# Access Compliance Report

## Public Rights-of-Way

### (Curb Ramps)

Intersection ID: 46308	Main Street: DONNEGAL_FARM_RD	Cross Street: BECKET RIDGE_RD	Location: SW
ADA ID: 0FEB8384A02A	Ramp Type: PerpDiag	Initial Pass/Fail: Fail	Overall Compliance: No
Severity Score: 8.75			
Codes/Mitigation Info/Possible Solution		Field Measurements/Component Compliance

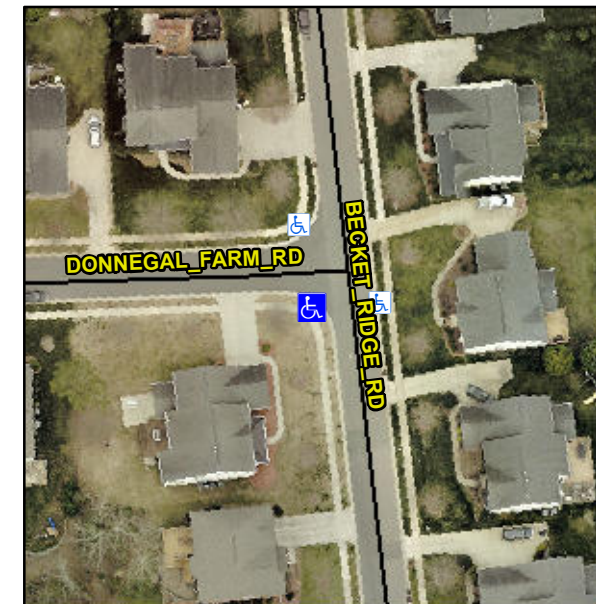
**Not Found, R304.5.1**

Compliance	Description	Data	Compliance	Description	Data
N/A	Ramp Length (in)	49.0	Yes	Ramp Slope (%)	5.2
No	Ramp Width (in)	47.5	Yes	Ramp XSlope (%)	0.8
N/A	Flare Type LT	N/A	N/A	Flare Type RT	N/A
N/A	Flare Slope LT (%)	N/A	N/A	Flare Slope RT (%)	N/A
N/A	Flare Traversable LT?	N/A	N/A	Flare Traversable RT?	N/A
N/A	Landing Length (in)	N/A	N/A	DWS Provided?	N/A
N/A	Landing Width (in)	N/A	N/A	DWS Contrast?	N/A
N/A	Landing Slope (%)	N/A	N/A	DWS Length (in)	N/A
N/A	Landing X Slope (%)	N/A	N/A	DWS Full Width?	N/A
N/A	Landing Curb? (Y/N)	N/A	N/A	DWS Offset (in)	N/A
N/A	Shared Landing?	N/A			
N/A	Gutter Ponding?	N/A	N/A	Gutter Slope (%)	N/A
N/A	Gutter Lip Ht (in)	N/A	N/A	Gutter X Slope (%)	N/A
N/A	Painted X Walk1?	No	N/A	Painted X Walk2?	No
	X Walk 1 Direction	To E		X Walk 2 Direction	To N
N/A	X Walk 1 Width (in)	N/A	N/A	X Walk 2 Width (in)	N/A
	X Walk 1 Slope (%)	1.6		X Walk 2 Slope (%)	4.4
	X Walk 1 X Slope (%)	4.8		X Walk 2 X Slope (%)	3.6

N/A	Ramp inside XWalk1?	N/A	N/A	Ramp inside XWalk2?	N/A
	Road Slope (%)	0.5	N/A	Clear Space?	N/A
	Road X Slope (%)	5.9	N/A	Clear Space to XWalk (in)	N/A
N/A	Any Obstructions?	N/A	N/A	Storm Grate/Utility Hazard?	N/A
	Obstruction Type			Storm Grate/Utility Type	
		N/A			N/A
			Yes	Surface Condition? (G/P)	Good

**Remove & Replace Curb Ramp With Two New Directional Ramps or Equivalent.**
